Design Review Board Meeting

Tuesday, December 10, 2024, 2:30 PM

Dear Design Review Board,
Enclosed you will find our Final Submittal for the new Archeology Research Facility at Historic Mitchelville Freedom Park. This project is part of a larger previously approved Master Plan.

**Archeology Research Facility
40 Harriet Tubman Way - Final
Plan Set
December 10, 2024
DRB-001479-2024**

LANDSCAPE PLAN

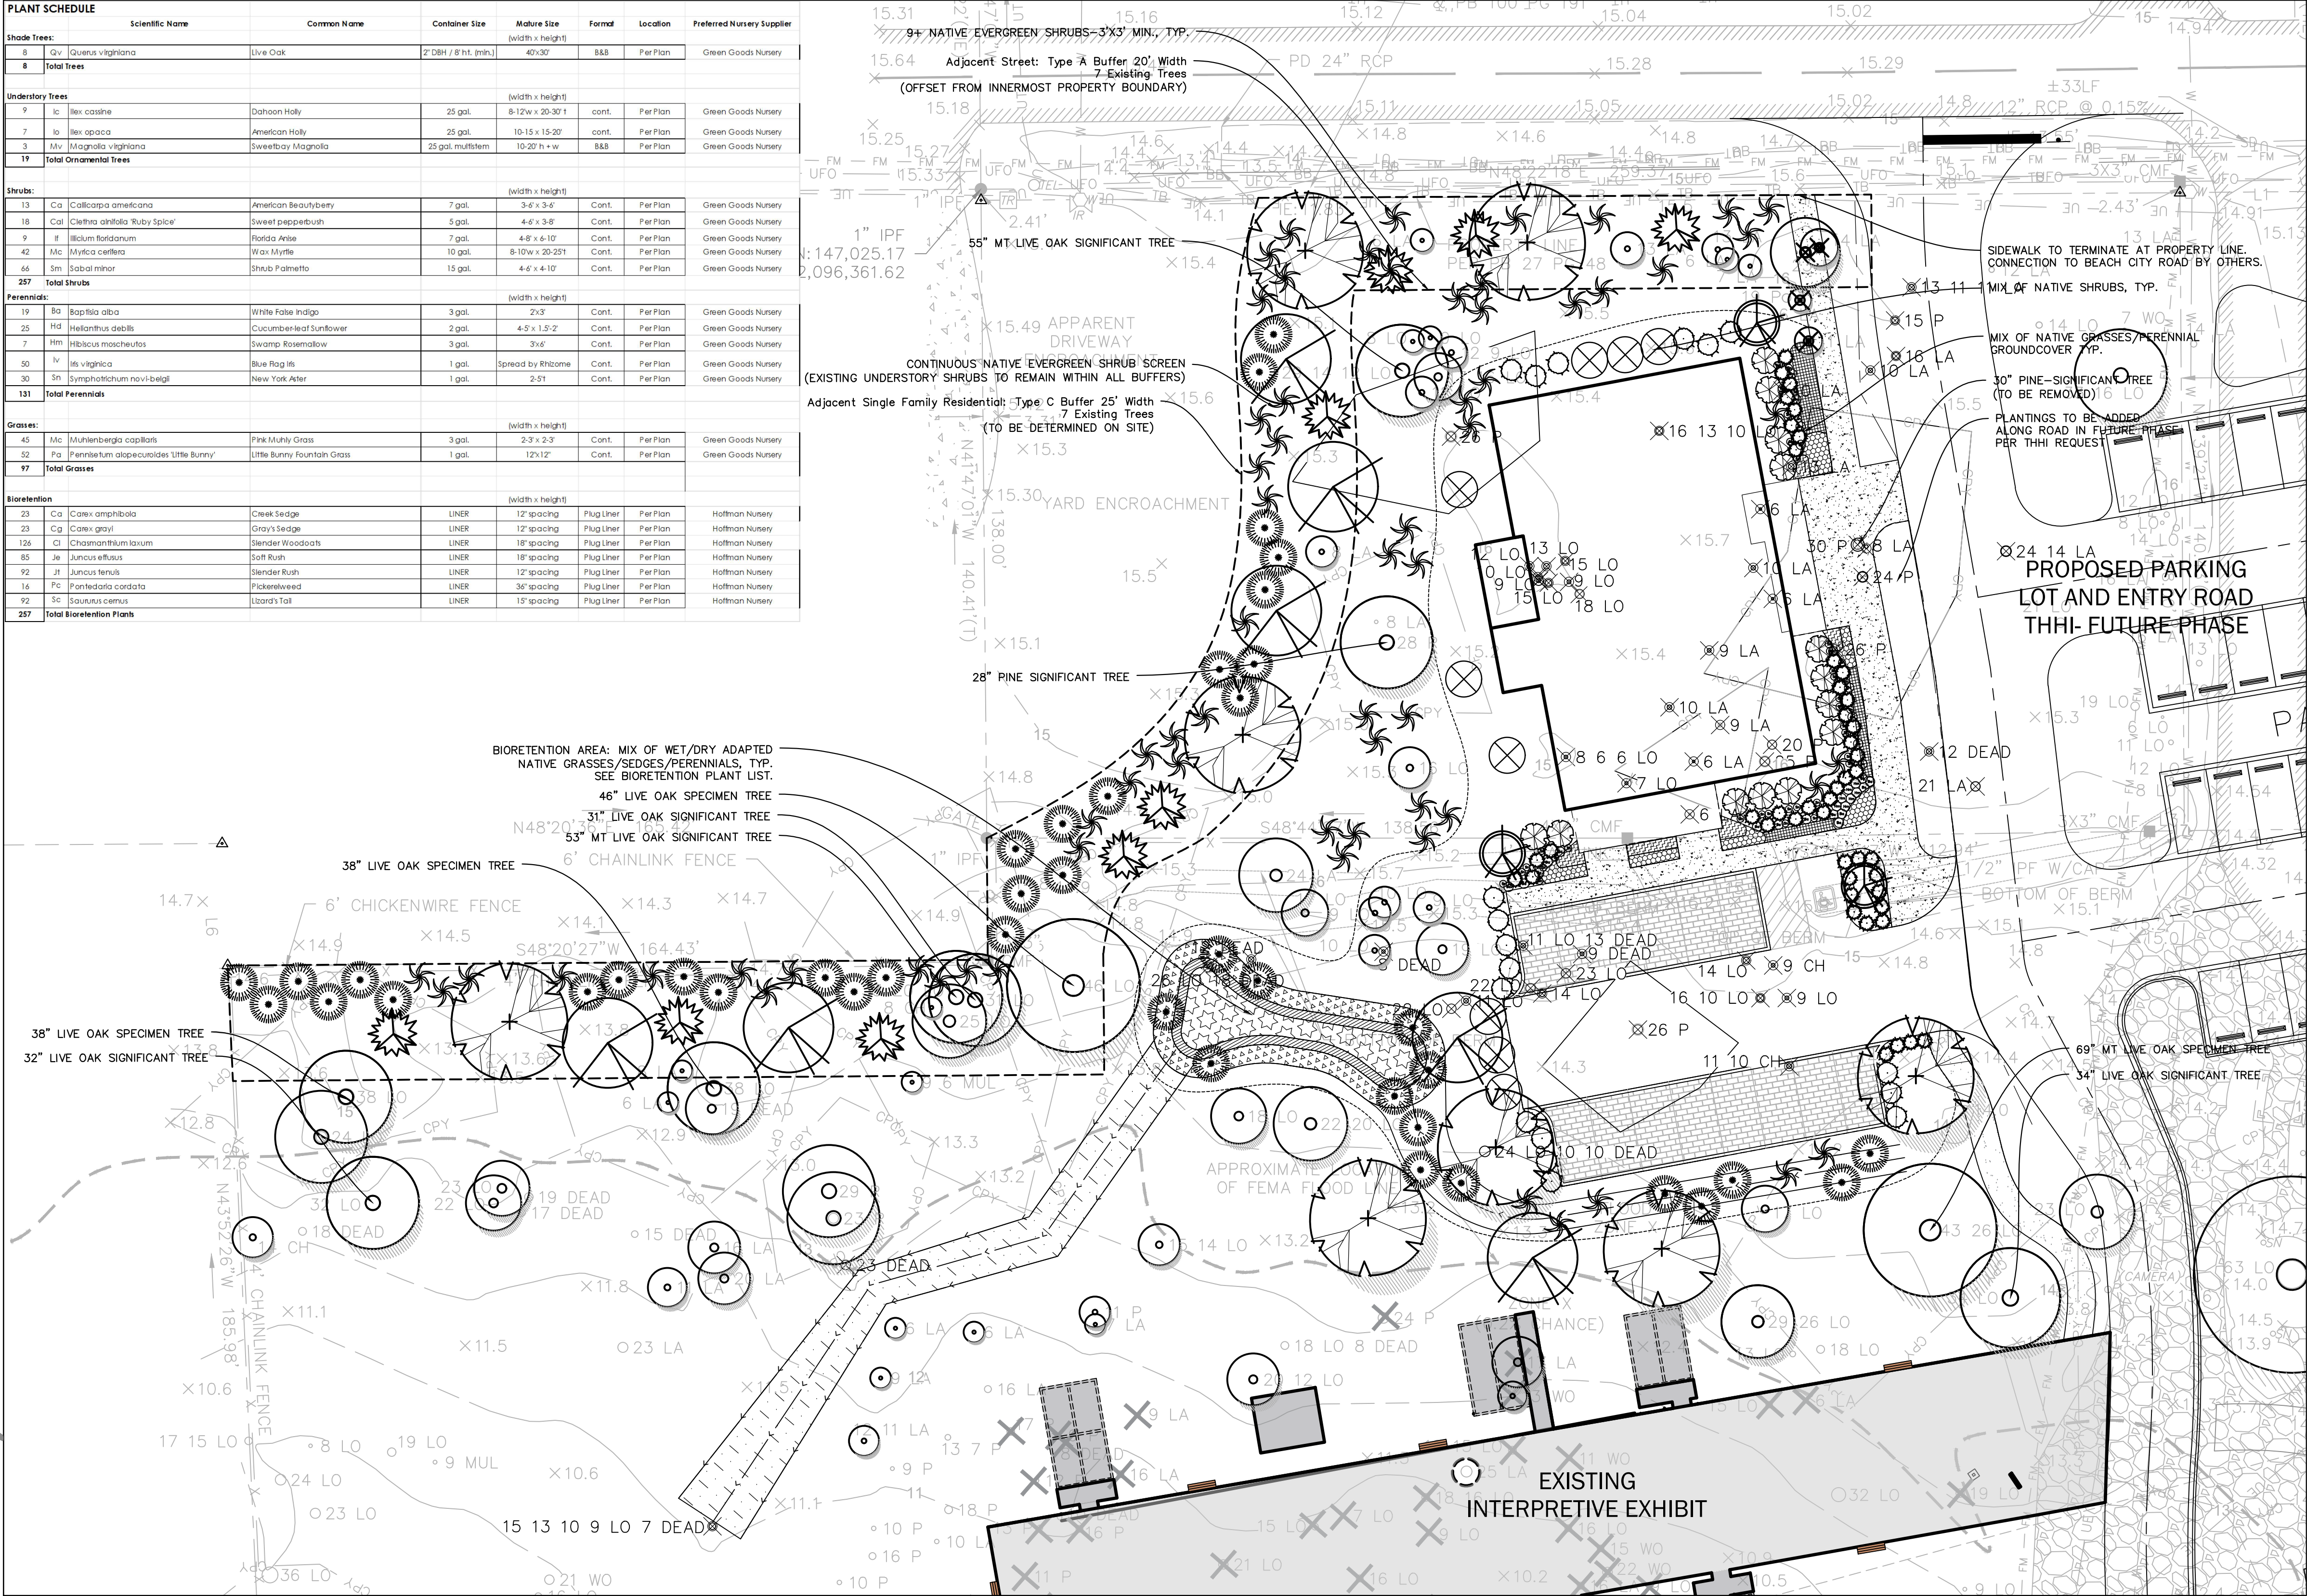
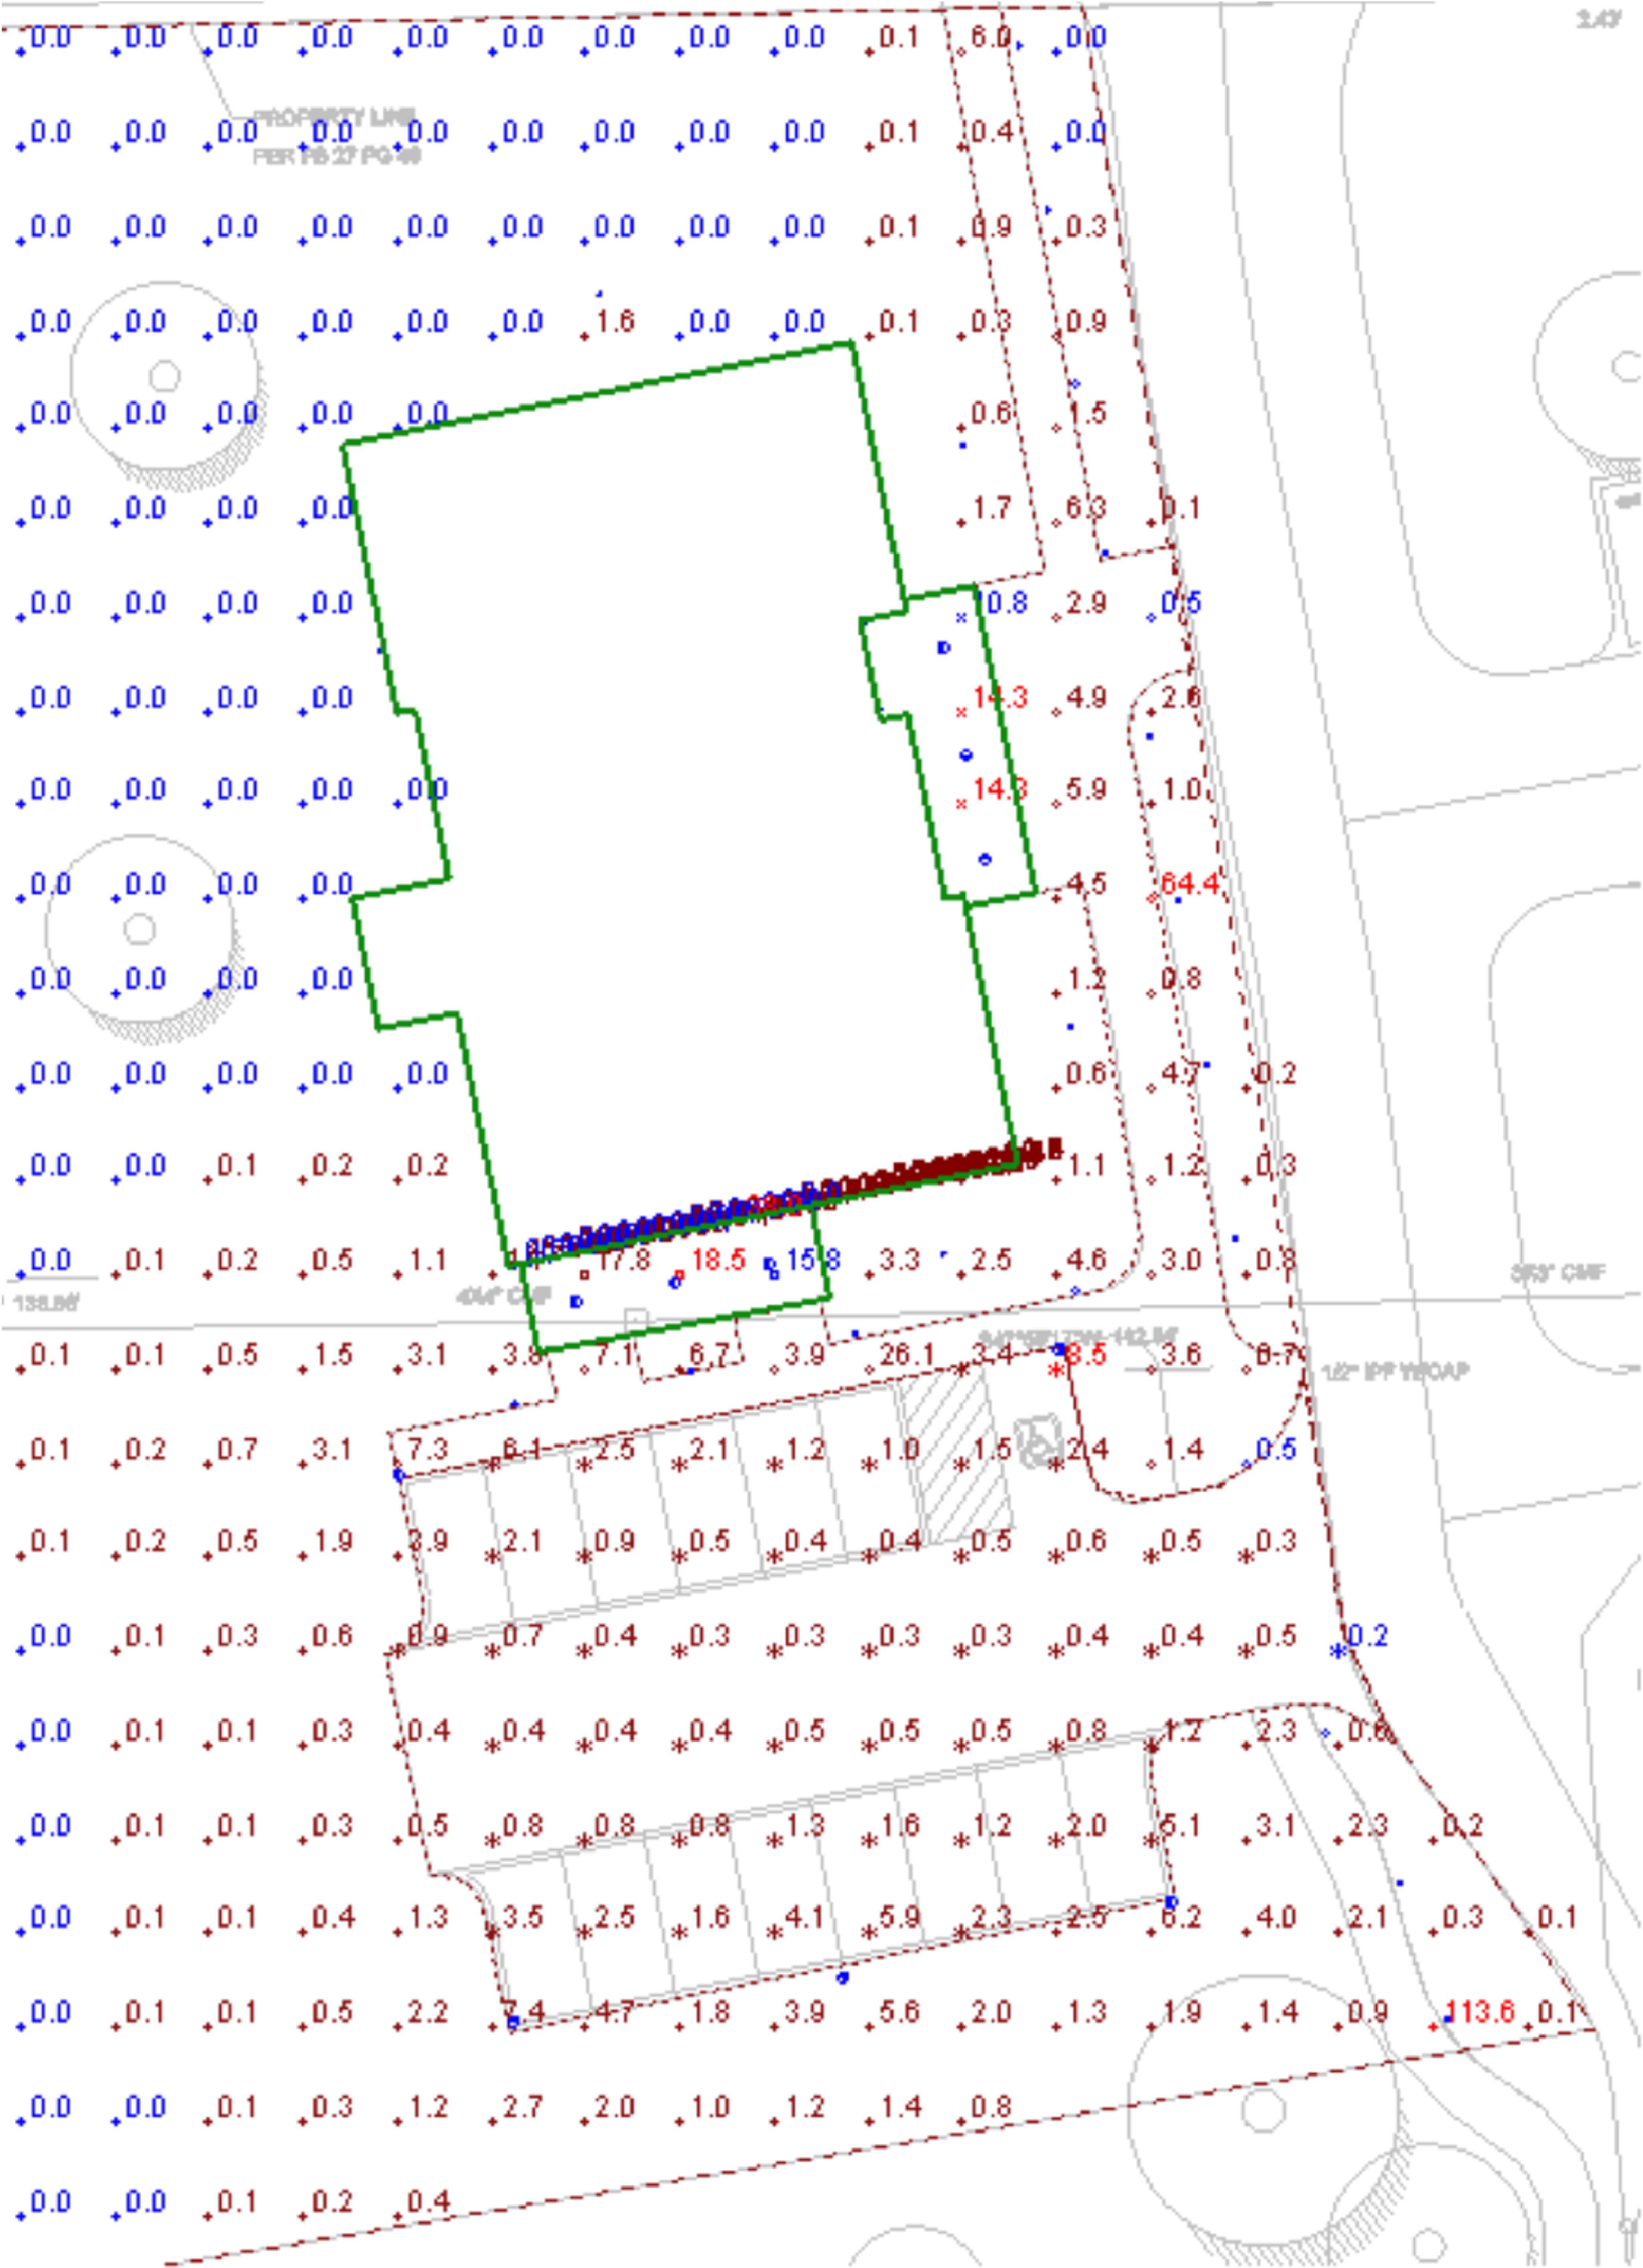
3. (ARCH/LAND) Is a Tabby sidewalk or pavers planned for the entry (arch & landscape showed different) - if pavers DRB would like them to be pervious.) *Tabby sidewalks, See updated Landscape Plan.*

4. (LAND) Be more clear about what sidewalks are within the scope. Kepple pointed out the note on the landscape drawings, DRB suggested adding another note. *See updated Landscape Plan. Thomas & Hutton plans to pick up the sidewalk from the property line to the driveway apron at Beach City Road as part of the Town Parking Lot project. Sidewalks along Beach City Road are not planned at this time.*

7. (LAND) Specified planting sizes seem small. DRB are concerned that small plants will have enough irrigation and future weeding would be an issue. *Solomon discussed this item in detail with Judd Carsons. All plant size specifications have been increased and available suppliers have been indicated where possible on the planting schedule.*
